ADDENDUM NO. 2

Reference: UVU Student Life Center & Parking Structure
Orem, Utah
DFCM Project No. 10289790

STUDENT LIFE CENTER & PARKING STRUCTURE

The original specifications and drawings, dated April 27, 2012 for the project referenced above are amended in this Addendum No. 2, dated May 04, 2012.

WALL SECTION - ZONE B _N4

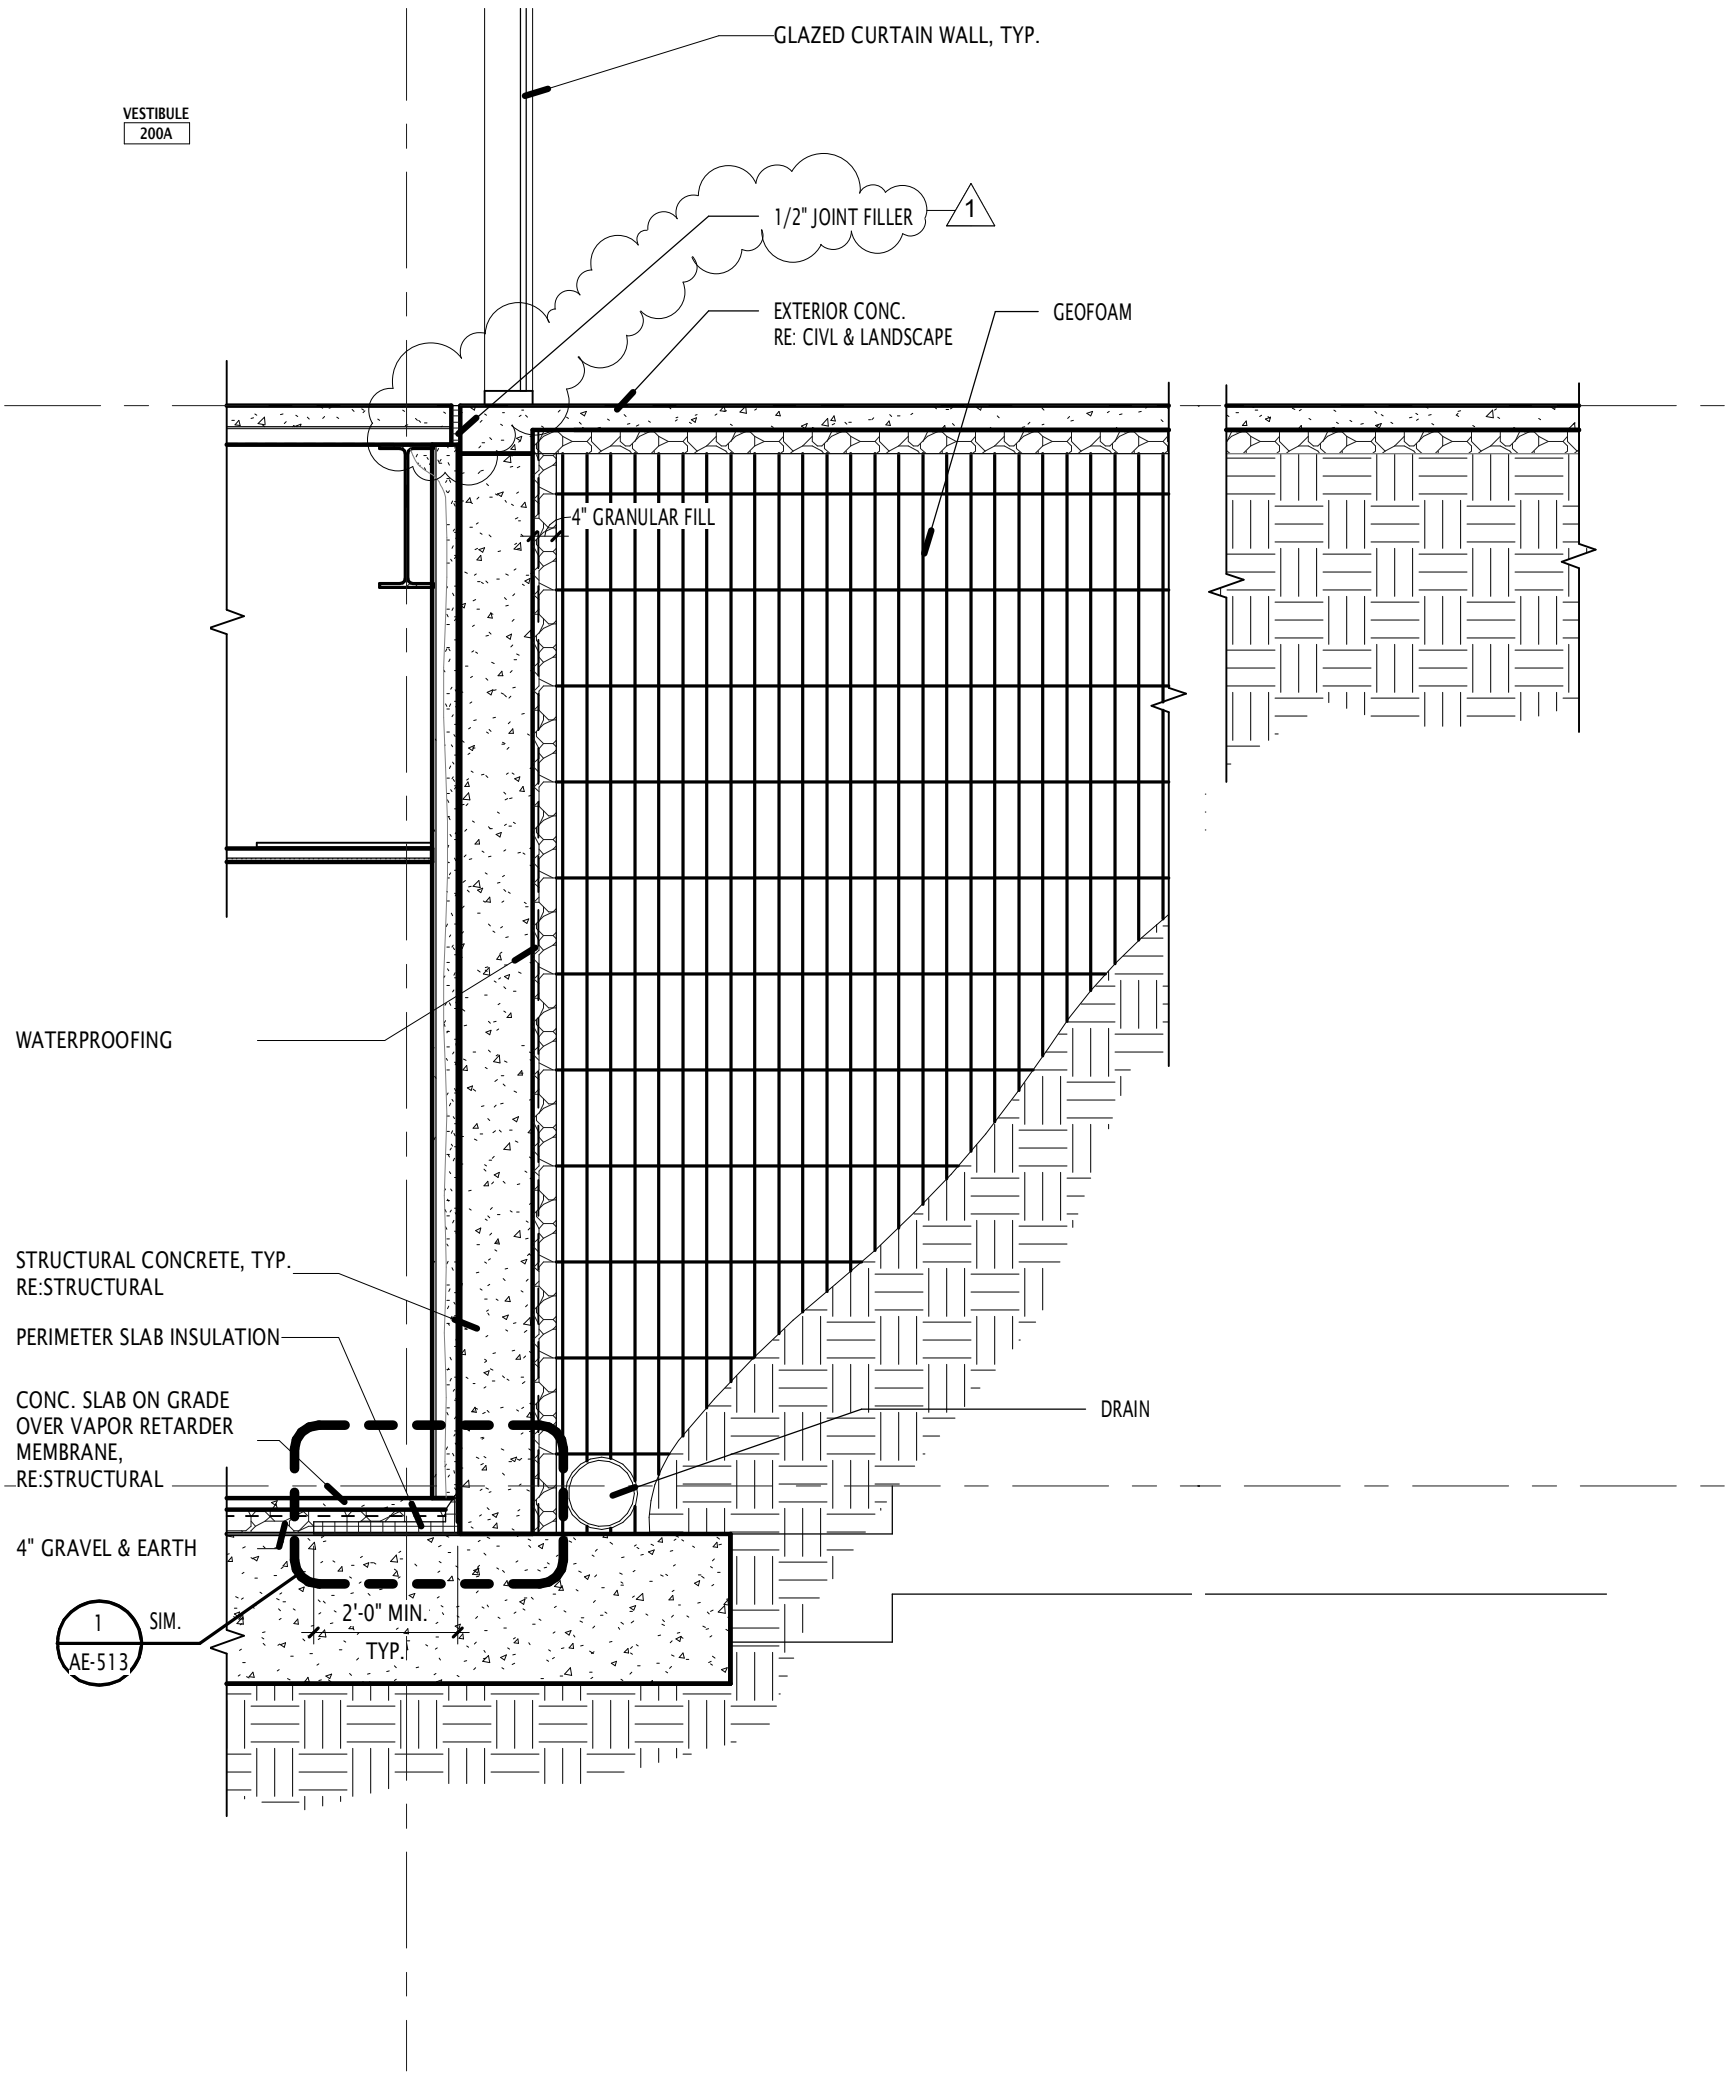
2-14	110100	Entire specification added
2-15	111400	Section 2.1 – Section to be renamed AUTOMATIC SECURITY BARRIER
2-16	323113	Entire specification added
2-17	GI-040	Revised special inspections and moved building code analysis to new sheet GI-050.
2-18	GI-050	New sheet issued for building code analysis
2-19	AE-111a	Renumbered old door 200F-1 to 101A-2, definition to concrete topping slab in Student Council Chamber 114, updated wall tags on exterior wall furring.
2-20	AE-111b	Definition to concrete topping slab, add door tag 119-1 to the coiling security grill, added new wall tags.
2-21	AE-111c	Furring in IT rooms, updated wall tags.
2-22	AE-121	New detail references and sections, tie-off anchor system added, notation in the legend.
2-23	AE-135	Update to window treatment schedule
2-24	AE-315	Detail 1-Update to visible items and topping slab. Detail 3-Add topping slab and detail bubble.
2-25	AE-316	Add joint filler at floor slab.

ENLARGED LAUNDRY ROOM PLAN

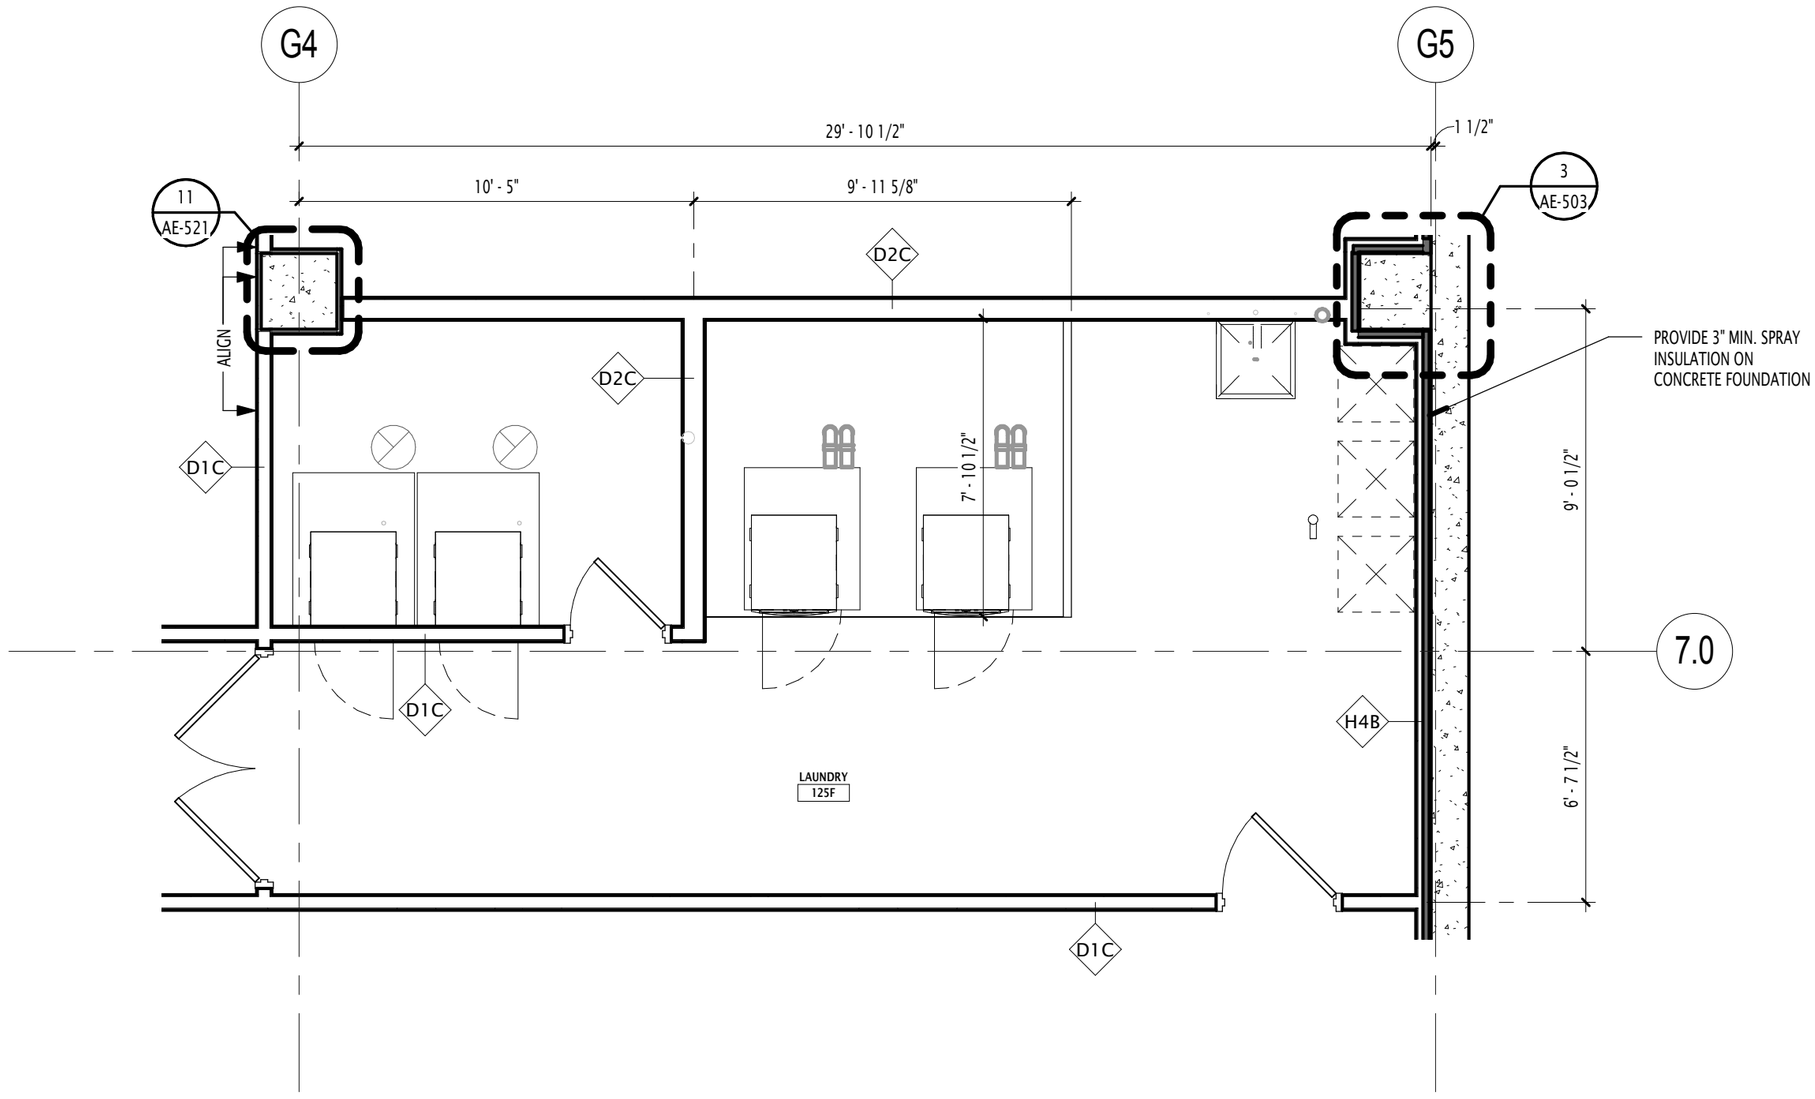
2-25	AE-411	Detail 1-Aligned Walls.
2-26	AE-412	Detail 1-Changed wood laminate notation to SS-1, added detail reference, Detail 2-Detail reference added, Detail 3- Added callout, Detail 4- Removed detail reference, Detail 6- Added detail reference, Detail 7-Added detail reference, General note. Detail 10 added.
2-27	AE-413	Details 2,4,6,8,10-Added and corrected detail references, Additional general note. Details 3 and 7-Corrected References.
2-28	AE-414	Details 11 and 12-Added detail references, General note to sheet. Added new detail 10.
2-29	AE-415	Detail 5-Corrected detail reference, added general note.
2-30	AE-416	Detail 12-Added detail reference, general note.
2-31	AE-417	Detail 5-Added detail references
2-32	AE-420	Add general note #6 to read as follows: “STAIR TREAD AND LANDING DIMENSIONS TO INSIDE OF STRINGER U.N.O.”
2-33	AE-421	Details 1,2,3,5,6-Updated, general note about stair stringer dimensions, Sump in elevator pit noted.

STUDENT COUNCIL CHAMBER BENCH

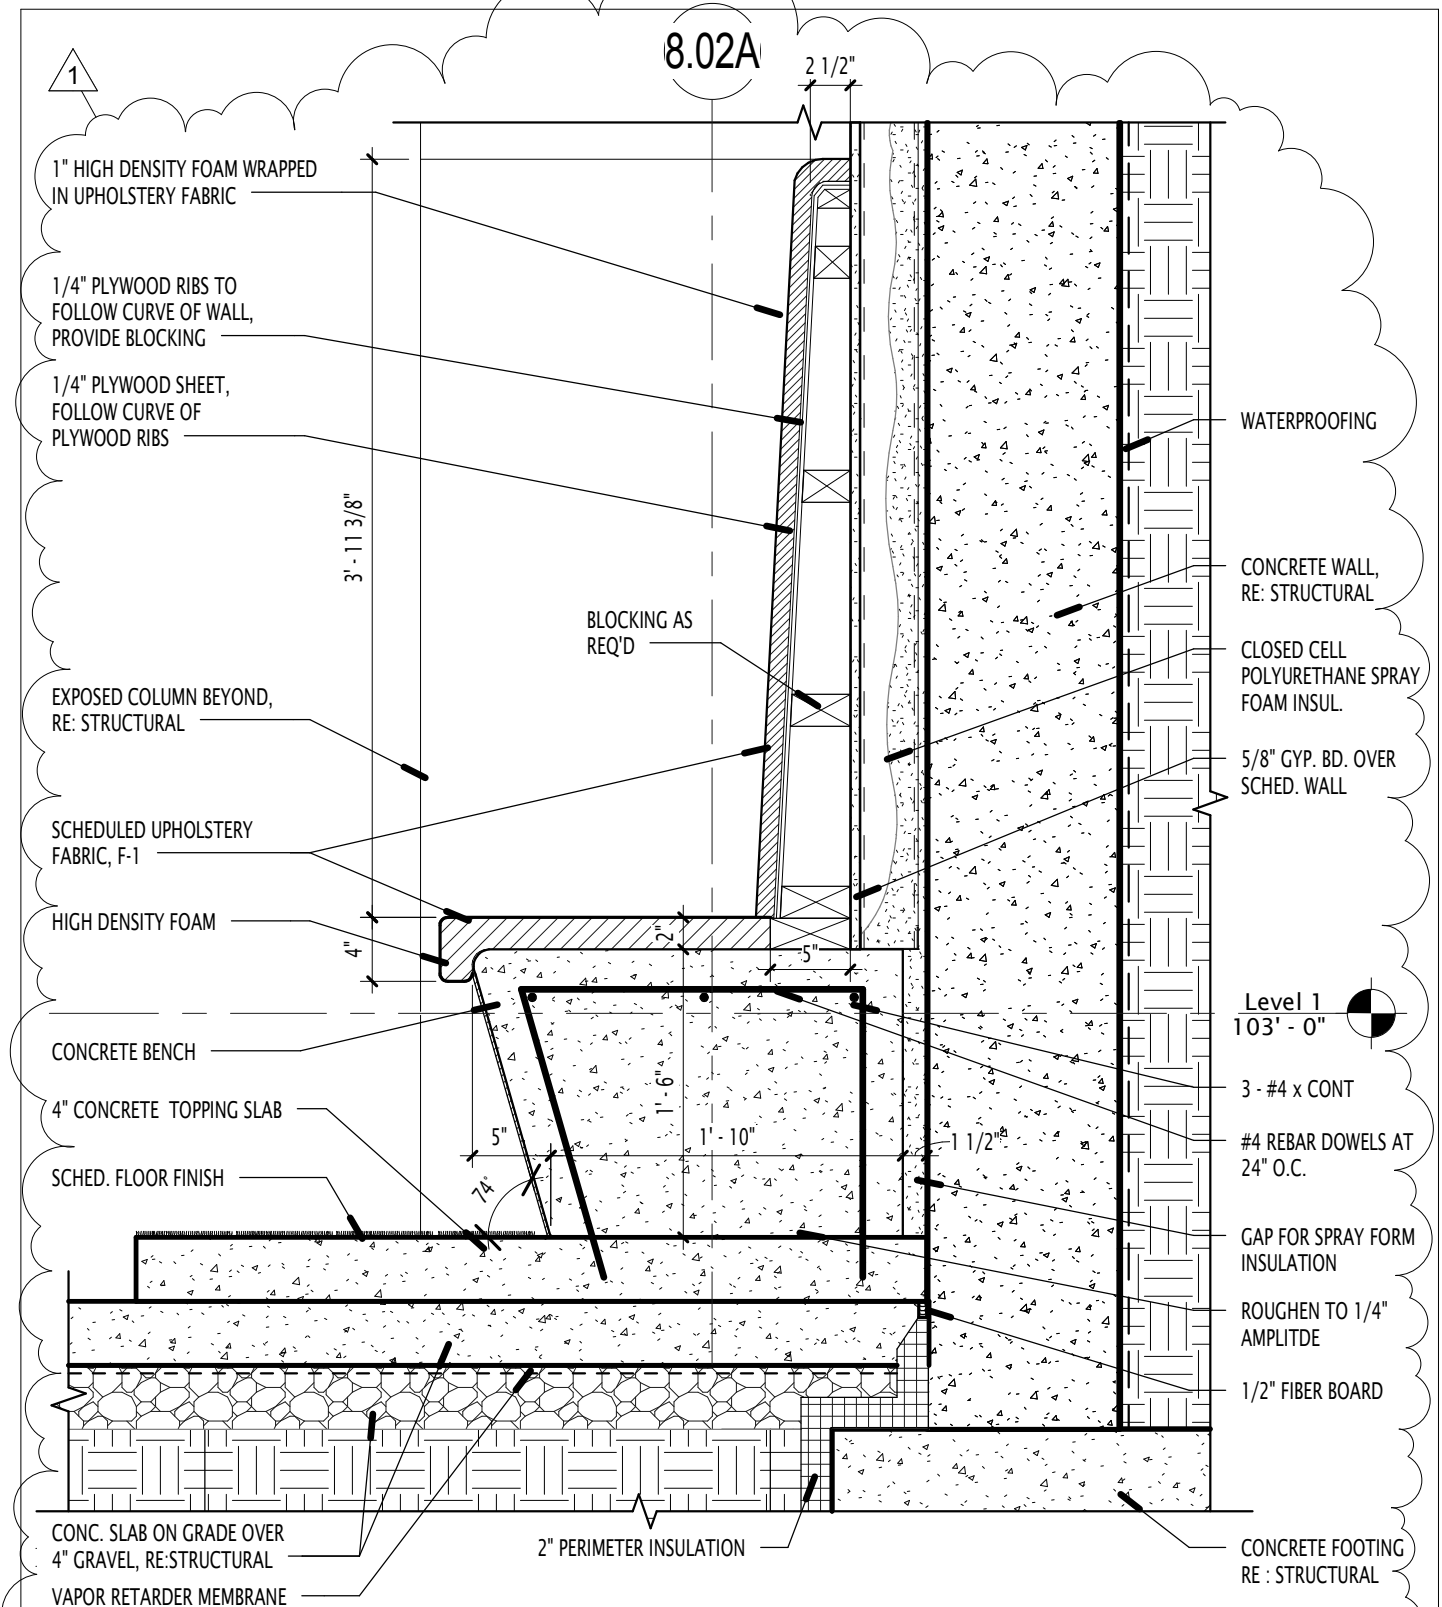
2-47	AE-516	Detail 11- Add topping slab and bench, removed brick.
2-48	AE-543	Detail 20-Duplicate Detail deleted.
2-49	AE-544	Detail 1-Text to indicate Phenolic Locker, not metal. Add rebar indications to the detail, Detail 10-Duplicate detail deleted and new detail added, Detail 13 revised.
2-50	AE-545	Adjustments or addition of details 4,7,8,12,15,16,17.
2-51	AE-562	Details 3,4,5 added showing cove lights in Bowling Alley.
2-52	AE-601	Elevations 1,4,9-Modified CP and DL locations, Updated glazing on SF1.
2-53	AE-602	Detail 1,3,4,7-Modified CD and DL locations.
2-54	AE-603	Detail 1,3- Added CP location, Changed glazing type at CW9.
2-55	AE-604	Detail 3- Added CP location.
2-56	AE-605	Detail 3,4-Added CP and DL locations, Added two new glazing type to the legend IG-1A - 1” Insulated Clear Non-High Performance IG-1AT - 1” Insulated Clear Non-High Performance Tempered Modified glazing type at CW22-a,b,c.
